Cumberhead West Wind Farm

EIA GATECHECK REPORT

October 2020

Figure 3
Layout B - Scoping

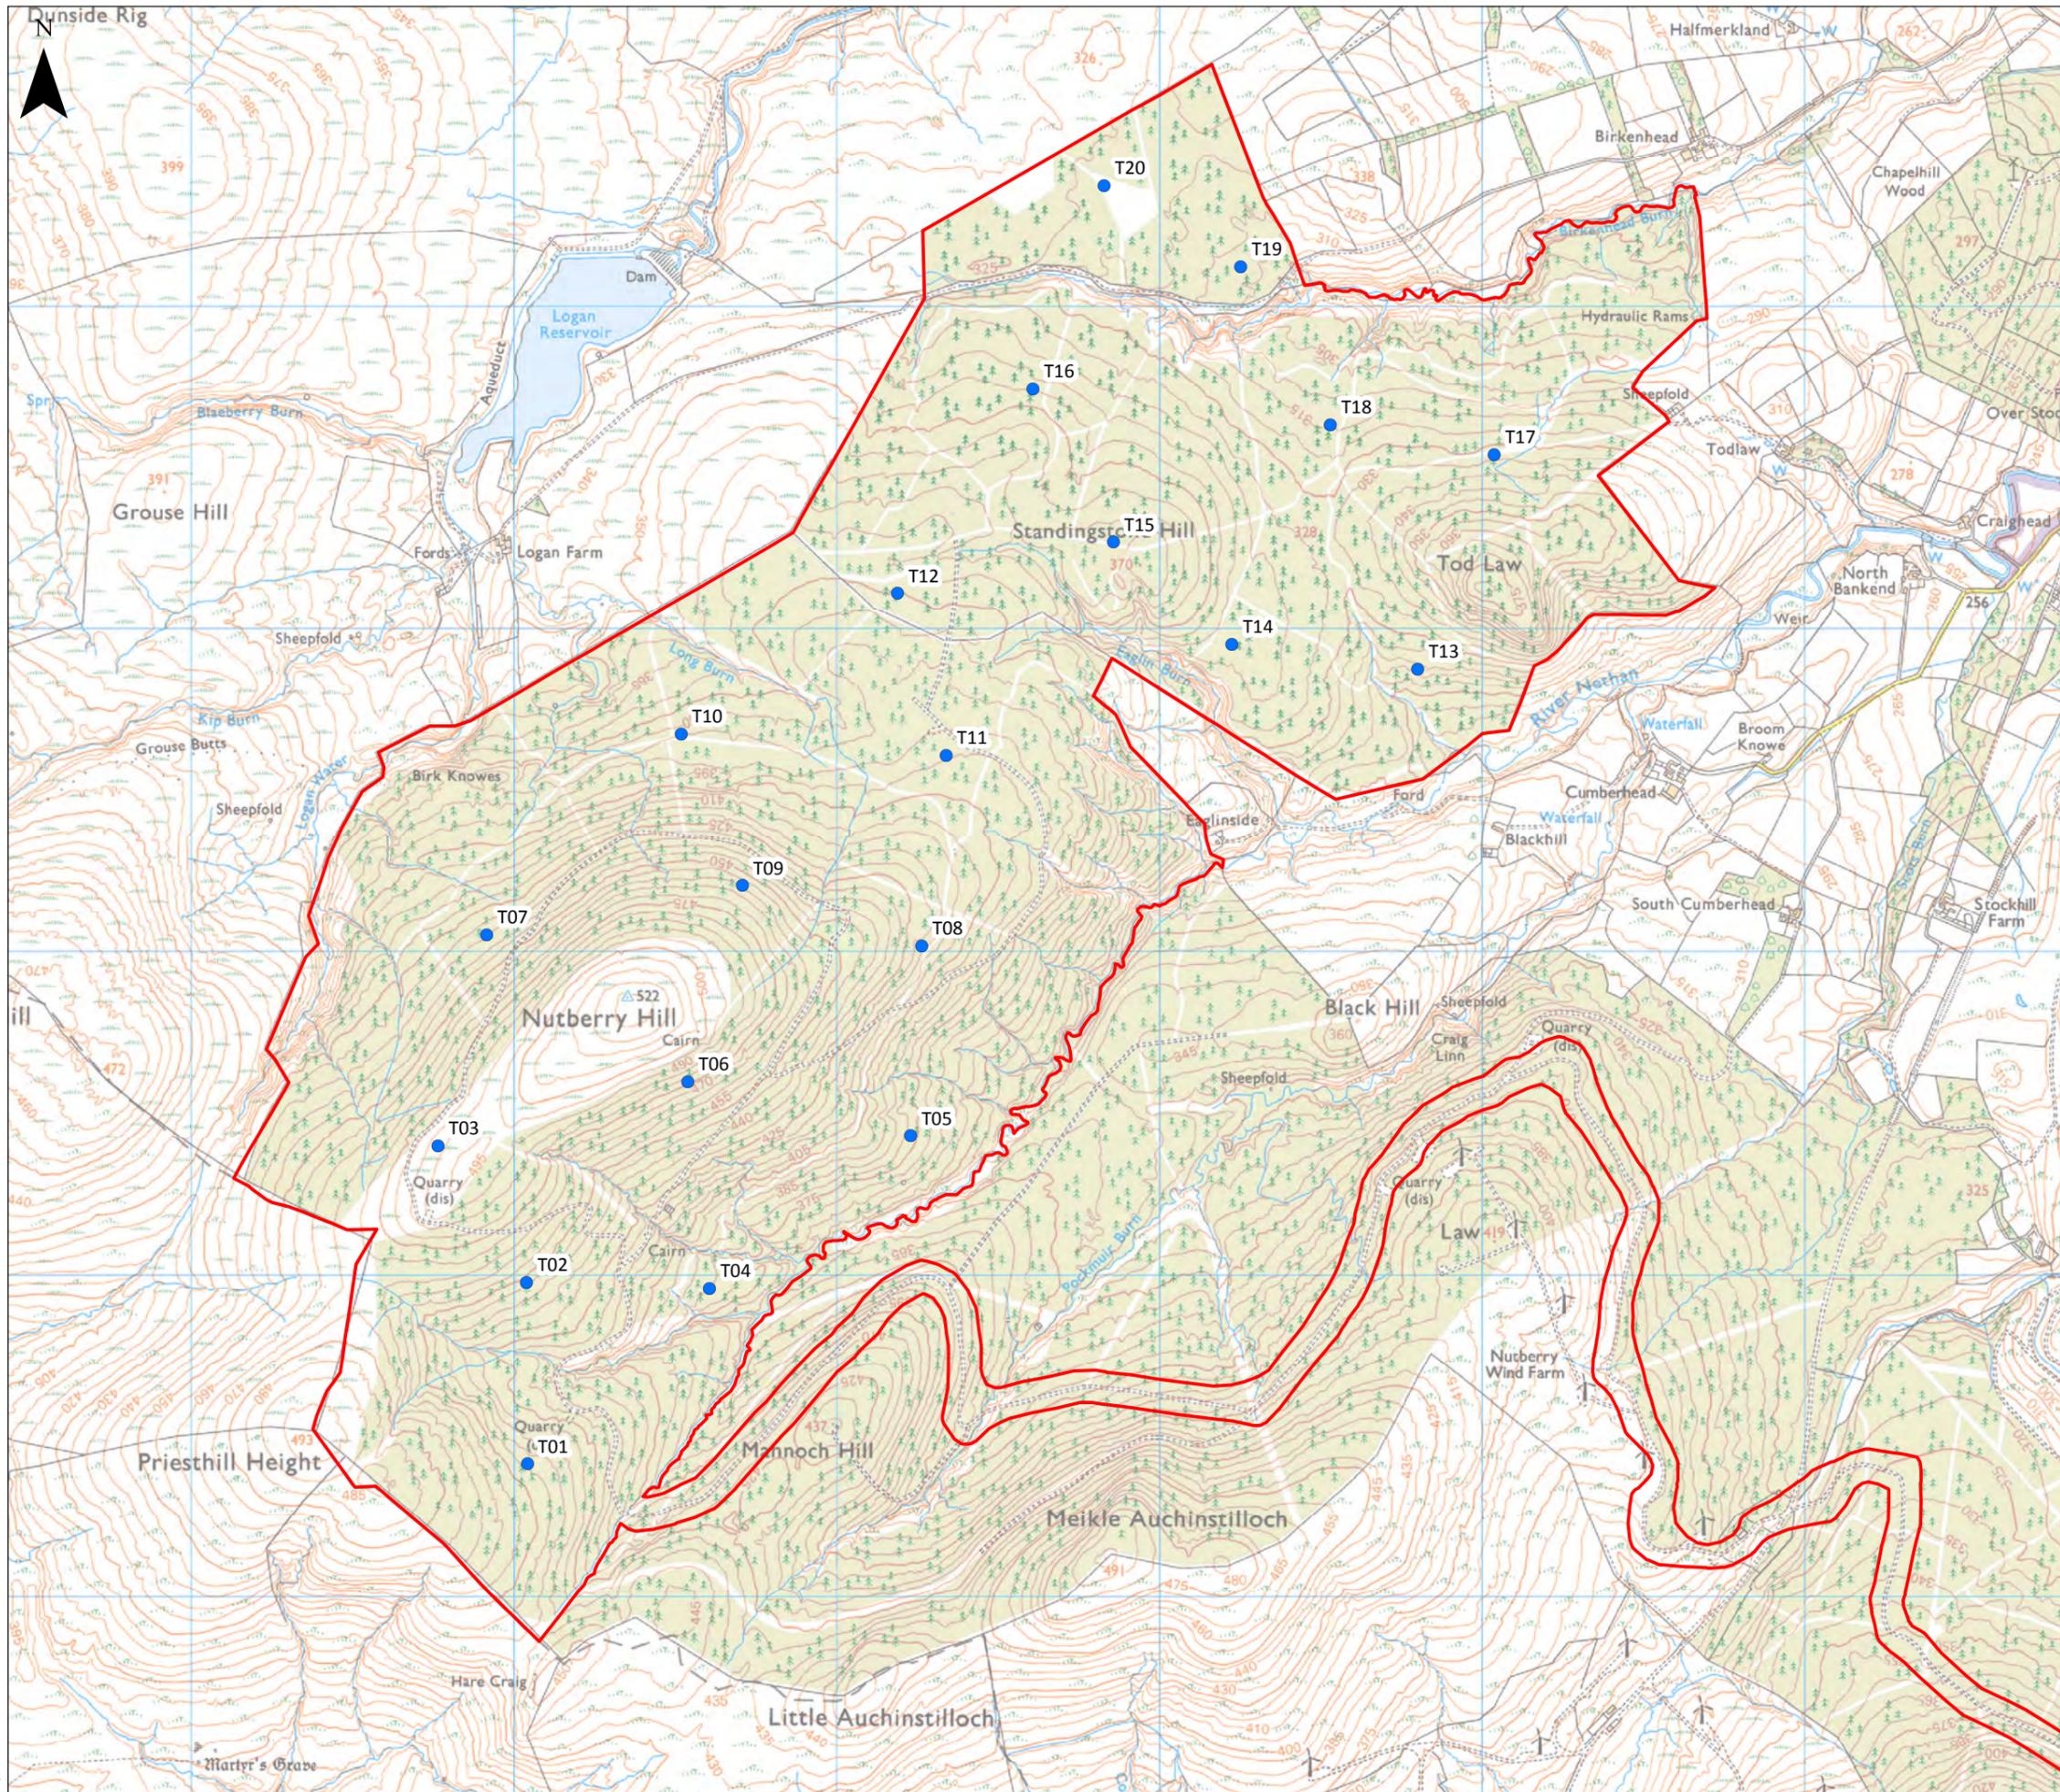
| Consultee | Scoping Comment | Response to Consultee | Further EIA Consultation |
|---|---|--|--------------------------|
| | Turbine locations and associated infrastructure may need to be modified as they are likely on deep peat. | The final design took into consideration the results of detailed Phase 2 peat probing and turbines and associated infrastructure were designed to avoid areas of deep peat where possible. Information on peat will be provided within the EIA Report (Chapter 11 Hydrology) | N/A |

| Design Iteration | No. Turbines | Date | Description |
|------------------|--------------|----------------|--|
| B (Figure 3) | 20 | June 2020 | Original scoping report design maximising capacity on the site with SPA buffer introduced and maximal use of existing on site infrastructure. The main developable area identified encompassed the extent of the Cumberhead forestry boundary. Layout B was developed from the initial layout to move turbines away from residential properties at Birkenhead Farm, as well as increasing the stand off to the Muirkirk and North Lowther SPA to the north and north west. The number of turbines was reduced from 26 to 20 turbines. |
